Technical Service Bulletin

NUMBER 67DT-44 MODEL A100

SUMMARY IMPROVED WHEEL CYLINDER DUST BOOT

DATE December 5, 1967
 NUMBER 67DT-46 MODEL D300 & W300
 GROUP SERVICE BRAKES SUBJECT REAR BRAKE DRUM MODIFICATION
 SUMMARY ADDITION OF A BRAKE SHIELD FOR OFF-ROAD OPERATION.

FIG. 1 BRAKE SHIELD

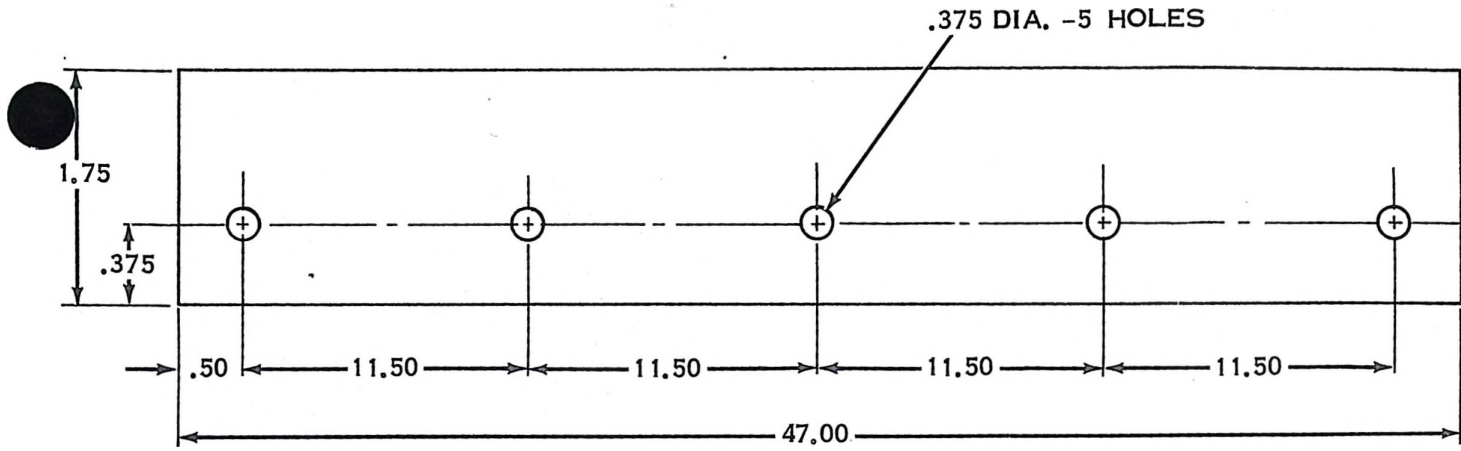
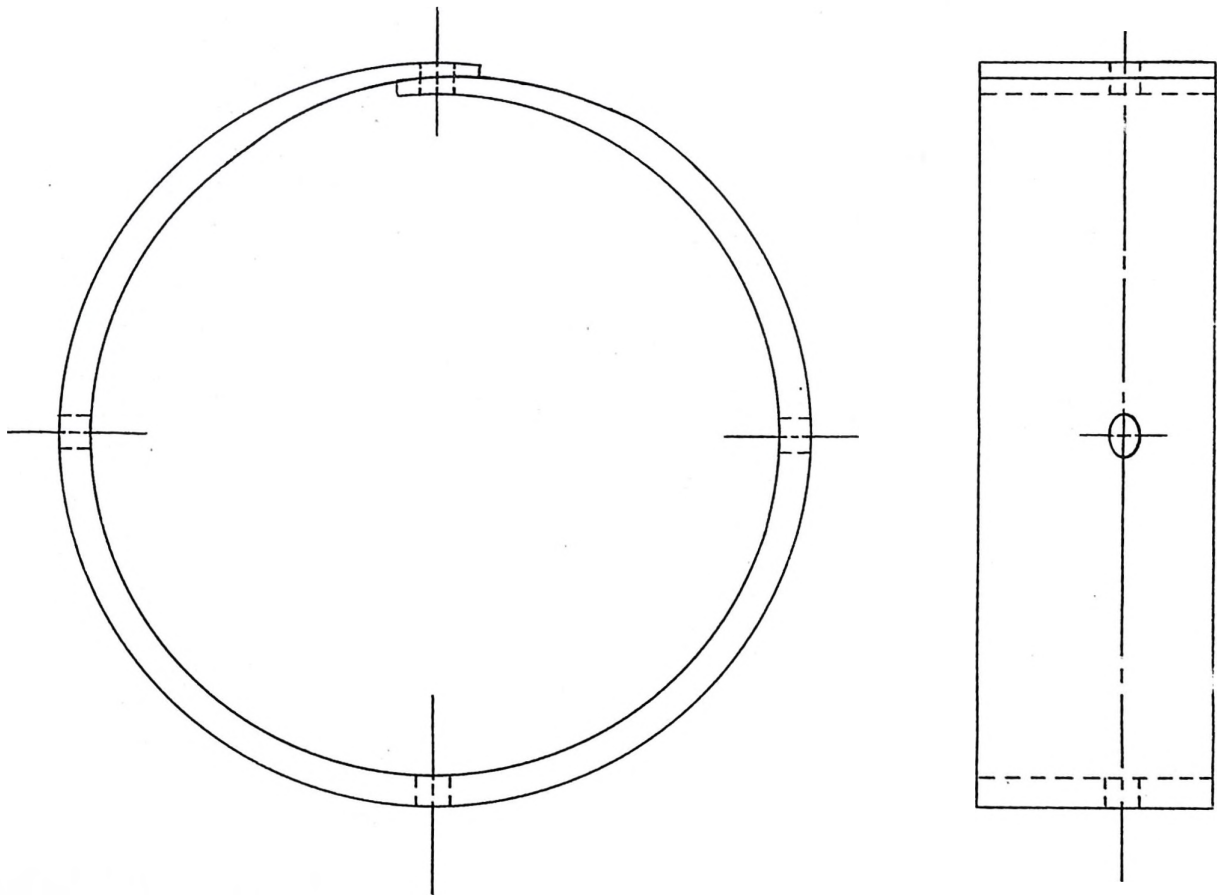
1. Jack up the vehicle and remove the rear wheels.
2. Fabricate a brake shield blank as shown on the attached sketch (Figure 1).
3. Drill one 17/64 dia. hole in the center of the brake drum squeal ring as shown on the attached sketch (Figure 2).

MATERIAL
18 GA. SHEET METAL

MOUNT BRAKE SHIELD TO DRUM FIG. NO. 2

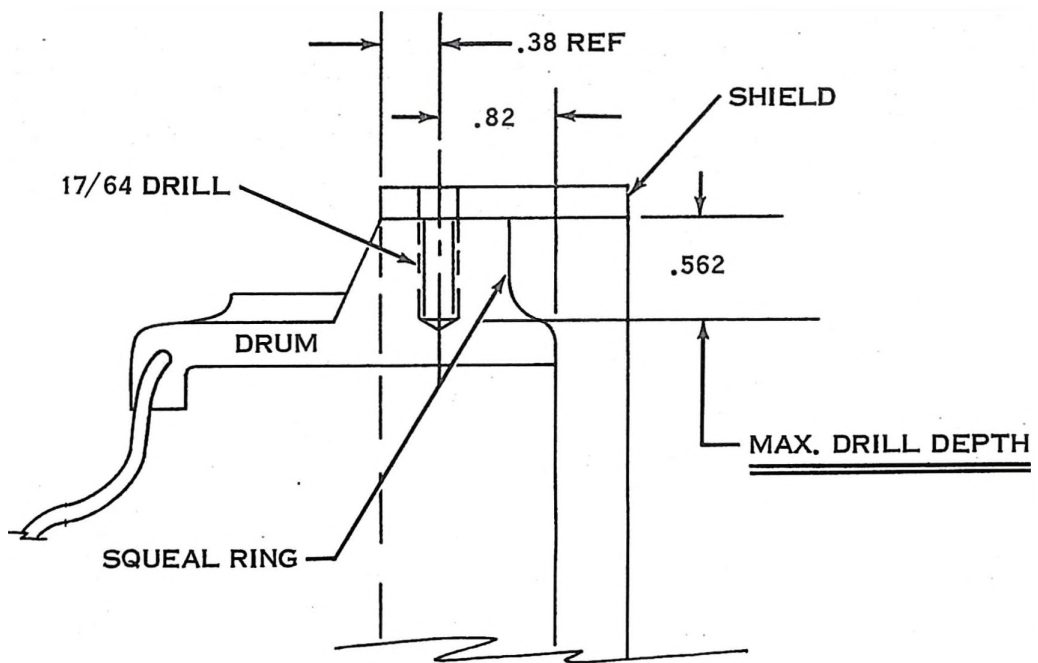
5. Over-lap the two end holes of the shield and install on the drum. Snug screw at this time, do not tighten.
6. Slide the brake shield over the squeal ring (tap with hammer if necessary) and position so that the outside edge is flush with the squeal ring (Figure 2).
7. Drill and tap the remaining three holes in the drum squeal ring as outlined in steps three and four using the .375 dia. holes for location.
